ECONOMISER ASSEMBLY

DRG NO : EC-01-GA-001

BOM CHECK SUMMARY

Drawing : sample_01_drawing.pdf (Rev B)
BOM : sample_01_bom.xlsx (Rev B)
Input : vector PDF
RUN RELIABILITY : HIGH

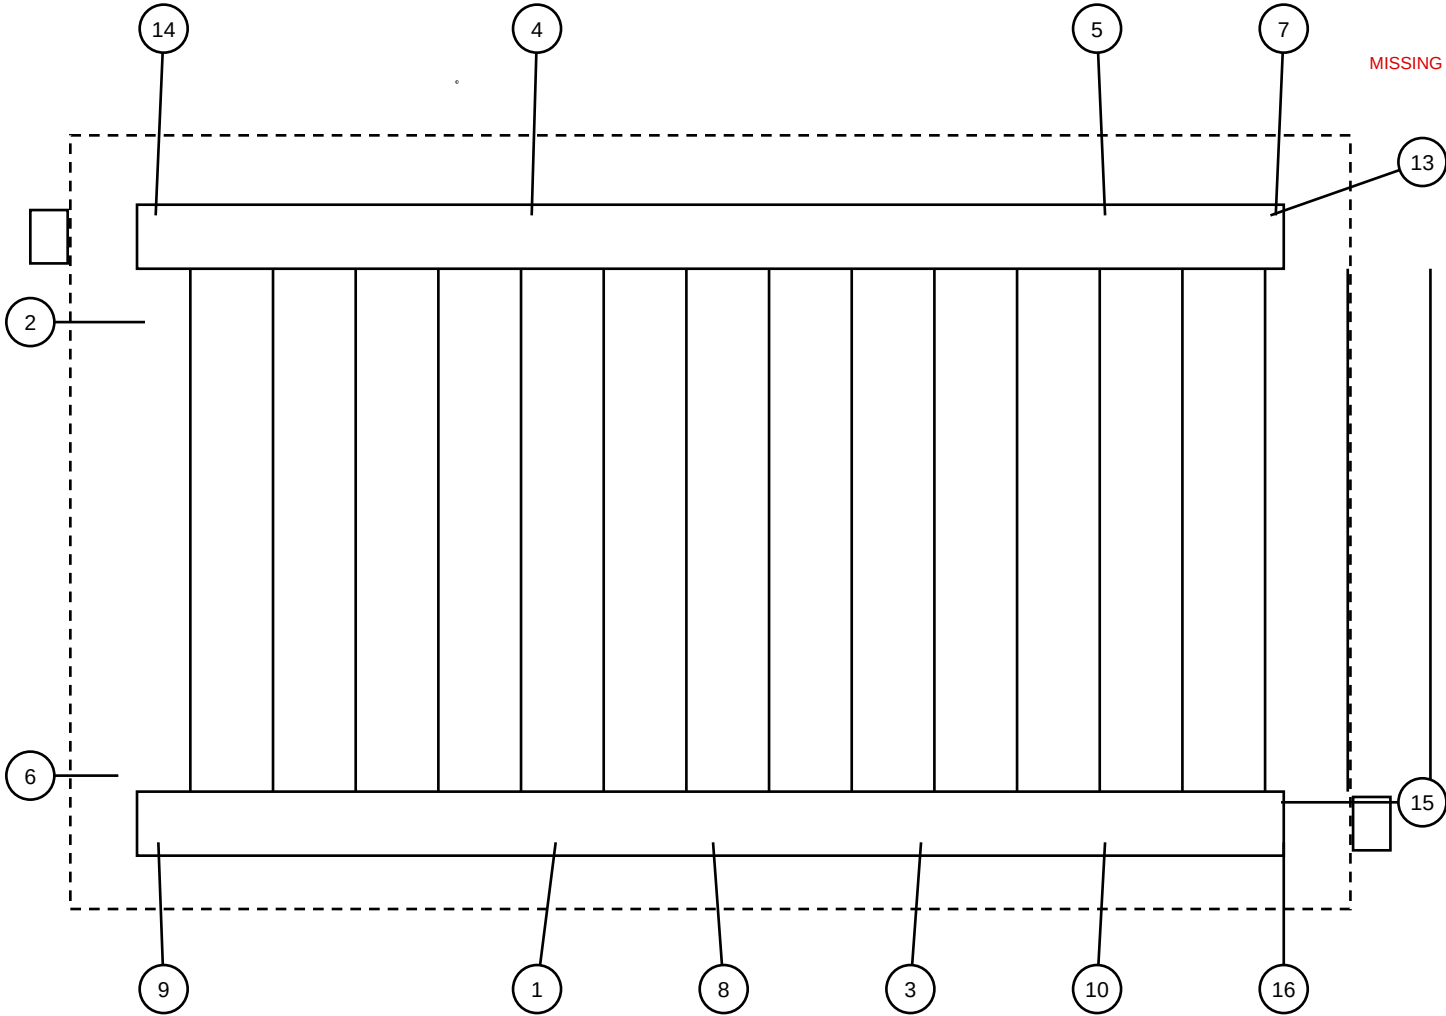
1. ALL DIMENSIONS ARE IN MM.
2. ALL WELDING AS PER IBR / ASME SEC I.
3. INSULATE WITH 100 THK MINERAL WOOL AND CLAD WITH 0.6 THK ALUMINIUM SHEET. <- BOM LACKS: Cladding

Findings: duplicate 1, implied 1, omission 1, spec 1

[RED] Item 12 'STUD BOLT M20 X 90 WITH 2 NUTS' (qty 16) is on the drawing but has no BOM line
[ORANGE] Item 6: specification mismatch - dimension: drawing ['200'] vs BOM ['250']
[YELLOW] BOM row 23 'Outlet header 219.1 OD x 8 thk' repeats item 2 (already covered by BOM row 7)
[BLUE] Suggestion (Cladding): the drawing notes imply it, but no matching line was found in the BOM
